Service Letter No. SL-AG-94
3 November, 1980

ELECTRICAL SYSTEM MODIFICATION

- MODELS AFFECTED:** S2R, S/N 1416R thru 2452R with Pratt & Whitney PT6A-34AG Engine installed per STC SA3237WE amended 8/29/77 and per STC SA3238WE amended 8/29/77, S2R-T34 S/N 6000 thru 6049, S2R-T34 S/N T34-001 thru T34-052, S2R-T15 S/N T15-001 thru T15-014, S2R-T11 S/N T11-001 thru T11-003.

**Figure 1
BATTERY MOUNTING PLATE**

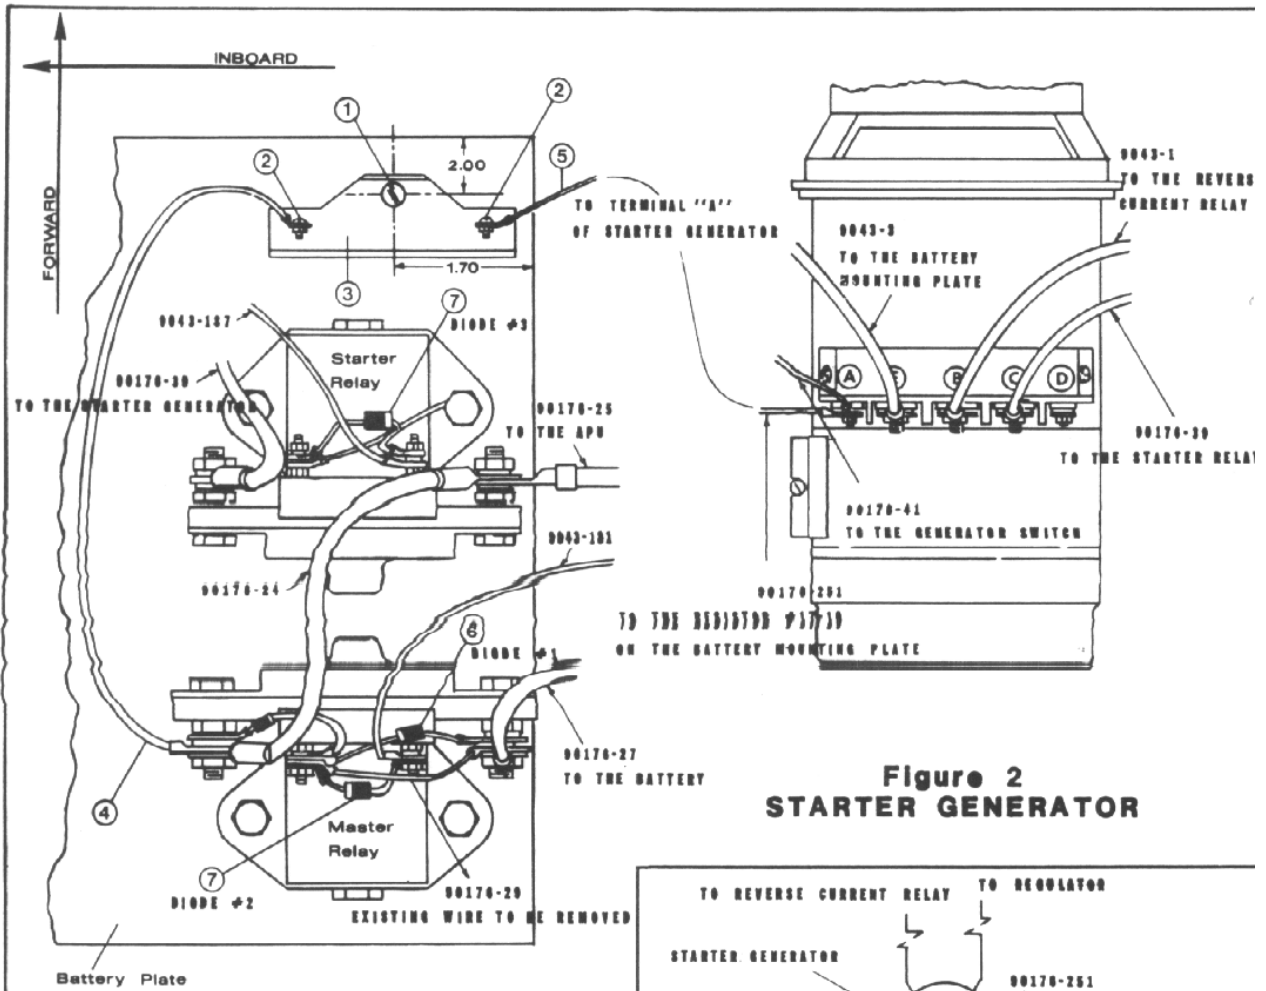
- 1 Remove wire No. 90176-29 from both terminals of the master relay and discard. (See Figure 1).
- 2 Connect the band end of the diodes No. 1 and No. 2 to the master relay coil terminal that the existing diode is attached. Connect the other end of diode No. 1 to the master relay terminal that has wire No. 90176-27 connected. Connect the other end of diode No. 2 to the master relay coil terminal that has wire No. 9043-181 attached. (See Figure 1)

- 3 Connect the band end of diode No. 3 to the master relay coil terminal that has wire No. 9043-187 attached. Connect the other end of diode No. 3 to the other started relay coil terminal. (See Figure 1).
- 4 Be sure that all the diodes are installed correctly. (See the Schematic)
- 5 Install the 150 OHM resistor P/N 17-10 to the battery mounting plate as shown in Figure 1.
- 6 Connect wire No. 90176-252 to the master relay terminal that has wire No. 90176-24 attached. Attach the other end of wire No. 90176-252 to the inbound terminal of the resistor P/N 17-10.
- 7 Attach wire No. 90176-251 to the outboard terminal of the resistor P/N 17-10. Attach the other end of wire No. 90176-251 to terminal "A" of the starter generator. (See Figure 1 and Figure 2)
- 8 Ensure that all wires are correctly connected prior to applying power and operating the engine. (Reference Schematic)

**Figure 3
WIRING SCHEMATIC**

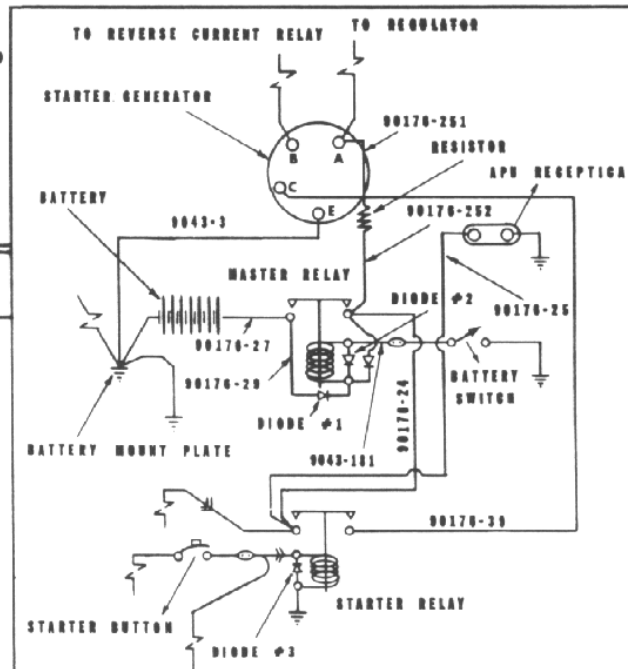
There are three (3) diodes and one (1) resistor that must be installed to insure proper operation of the electrical system in compliance with this Service Letter. To simplify the instructions the diodes will be referred to as diodes No. 1, No. 2, No. 3. Diode No. 1 and No. 2 will be installed on the master relay and diode No 3 will be installed on the starter relay. These relays are located on the right hand top on the battery mounting plate. The resistor will be installed on the battery mounting plate. It should be noted also that each diode has a solid stripe around it. This stripe indicates the direction of the current flow and also the direction in which the arrow points on the wiring schematic.
